### 3.4 Instrumentation and Control

STD DEP T1 3.4-1 (Figure 3.4a, Figure 3.4b, Figure 3.4c)

Figure 3.4a Safety System Logic and Control (SSLC) Control Interface Diagram

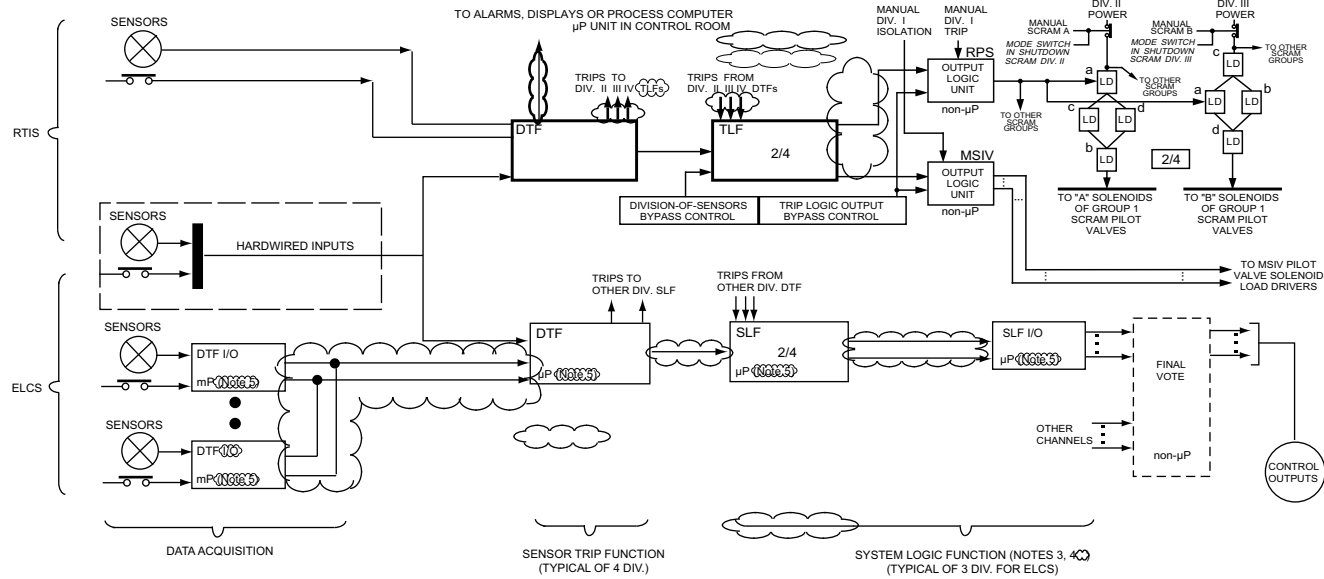
safety-related portions of the Neutron Monitoring System (NMS), the Containment Atmospheric Monitoring System (CAMS) and the radiation monitoring systems. The relationship between SSLC and systems for plant protection is shown in Figure 3.4a.

Figure 3.4b Safety System Logic & Control Block Diagram

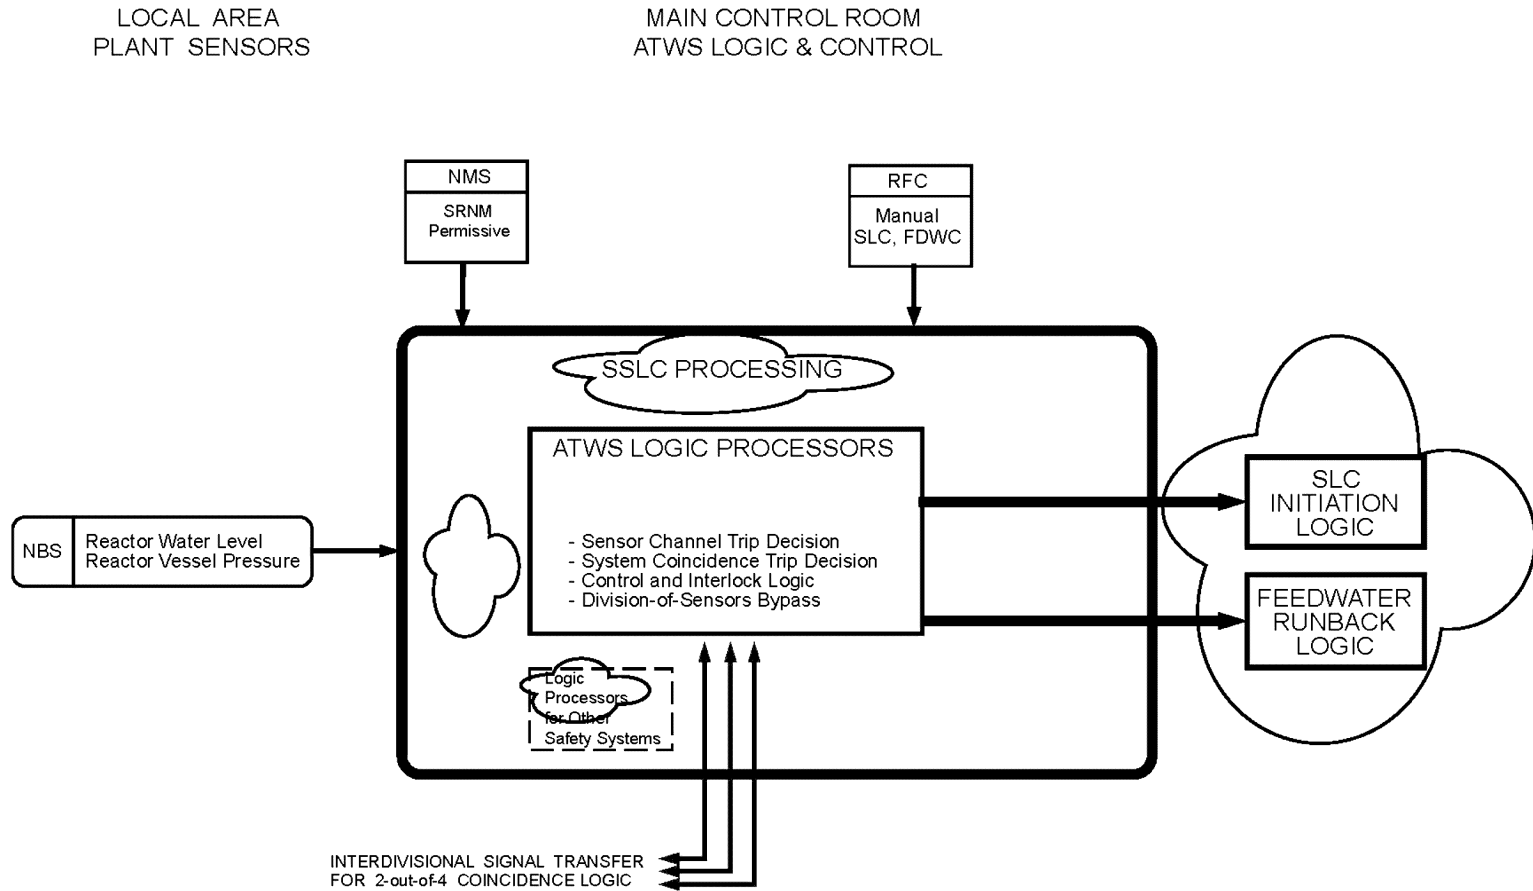
~~The basic hardware functional configuration for one division of SSLC is shown in Figure 3.4b. Each division runs independently (i.e., asynchronously) with respect to the other divisions. The following steps describe the processing sequence and associated function descriptions for incoming sensor signals and outgoing control signals. These steps are performed simultaneously and independently in each of the four divisions:~~

~~As shown in Figure 3.4b, a pair of SLU are located in each of two engineered safety feature (ESF) processing channels, ESF1 and ESF2. ESF1 processes initiation logic for functions which service the reactor vessel at low pressure (e.g. RHR), while ESF2 provides the same support for the vessel at high pressure (e.g. Reactor Core Isolation Cooling (RCIC) System and High Pressure Core Flooder (HPCF) System). Associated LDS and ESF functions are also allocated to these logic channels.~~
